9.1 Planning Application PLN18/0121 at 8 Montgomery Street, Doncaster East for the construction of 18 townhouses with associated basement car parking, and a reduction to the standard resident car parking requirements

File Number:	IN19/202
Responsible Director:	Director City Planning and Community
Applicant:	Simon Martyn - Fulcrum Urban Planning Pty. Ltd.
Planning Controls:	Residential Growth Zone, Schedule 3 (RGZ3), Design and Development Overlay, Schedule 13 (DDO13)
Ward:	Koonung
Attachments:	1 Decision Plans 2 Legislative Requirements

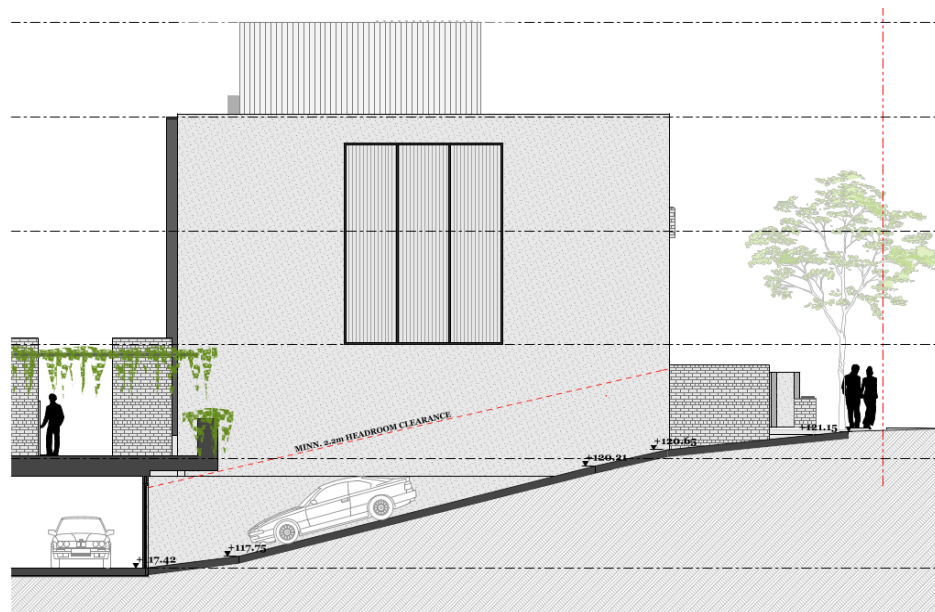
- 8.18 Whilst the fourth storey roof top terraces are relatively well setback from the street frontage, their expansion across the width of the northern building module increases the vertical wall heights up to four storey. This is exacerbated even further upon the eastern elevation where adjacent to the approach down into the basement (as shown in the below diagram) noting this will be visible from aspects along Montgomery Street.

- 8.19 Whilst the commercial interfaces can handle this more “robust” form, this same unrelenting approach to face residential interfaces is unsympathetic of the impacts upon the public and private realms.

Secluded private open space

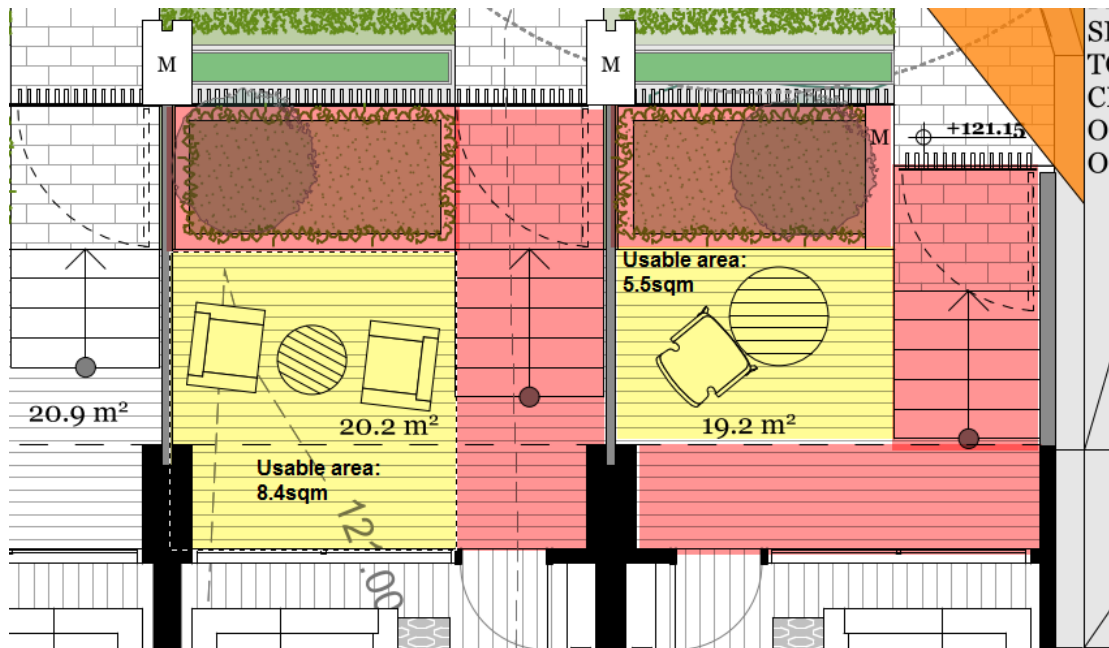
8.33 Each townhouse is provided with its “main” secluded private open spaces in the form of a ground level courtyard to the front of each respective row, and a service yard to the south. The four-storey dwellings are also provided with a north-facing balcony at the third storey, and roof-top terrace at the fourth.

8.35 The ground level courtyards are arguably intended to provide the main “secluded” POS of the dwellings, given this is the only space with convenient access from living room. The requirement for such space to be to the *side or rear* of a dwelling is to ensure residents are provided with a private area concealed from public view. These courtyards cannot be considered private by virtue of their locations (either within the front setback or facing the internal pedestrian path), and the public accessibility and exposure they will have being shared with dwelling entries and having transparent fencing.

8.36 Whilst the full 25sqm area may be difficult to achieve in a development of this style, the actual usable area of these spaces is almost halved when removing the required planting areas and space for pedestrian circulation to the entries. Although the open spaces are nominated as being 20sqm in area, the “usable deck” areas reduce to the order 8sqm, and even as little a 6sqm in instances through the simple failure to align the dwelling entries and gates. This is not commensurate to the recreational needs expected for a four bedroom dwelling.

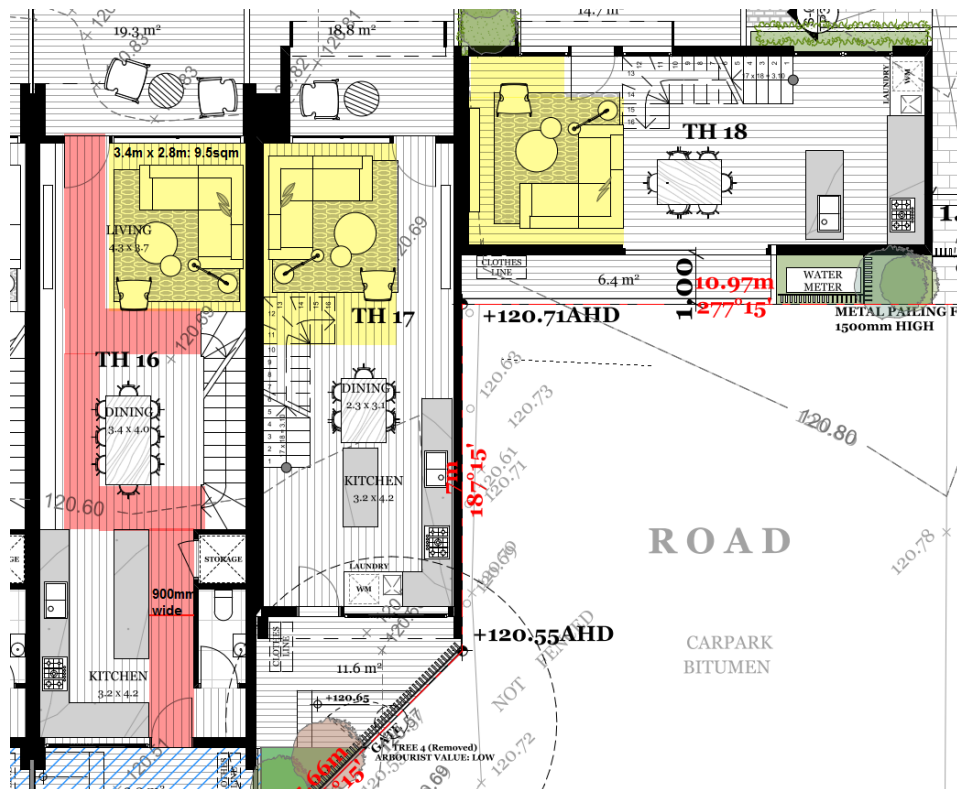
8.44 With exception of TH6, 17 and 18, the floorplans are replicated in widths and internal layouts, which are quite narrow and restrained overall. When excluding

circulation areas required to access the front door and internal stairs (as demonstrated in red for TH16 in the above plan), the living areas measure at only 2.7 metre by 3.4 metres and approximately 9.5sqm in total area. The Living areas for the Affordable Housing are also below the minimum recommendations, noting that of TH17 would be even less were the meals area shown with a more realistic dining table location.
